Specification Change Notice for Secondary filter of dust collector “DUSTCUBE” ODU-1000DSA-AT3

1. Affected product

DUSTCUBE model	Part name	Part number
ODU-1000DSA-AT3	Secondary filter (High performance filter)	CHF-2030-50

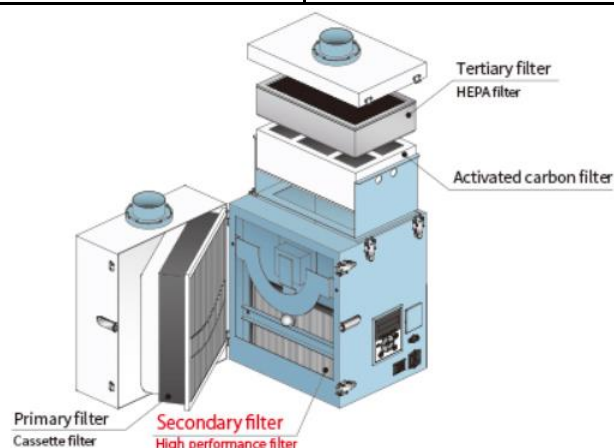
- Change of part number and material
- Removed the gasket on the frame

Item		Current	New
Gasket of this part is removed. 	Part number	CHF-2030-50	CHF-2030-50-F1
	Material (Filter/Frame)	Polypropylene/ Polypropylene	ABS/ Polyester + PTFE
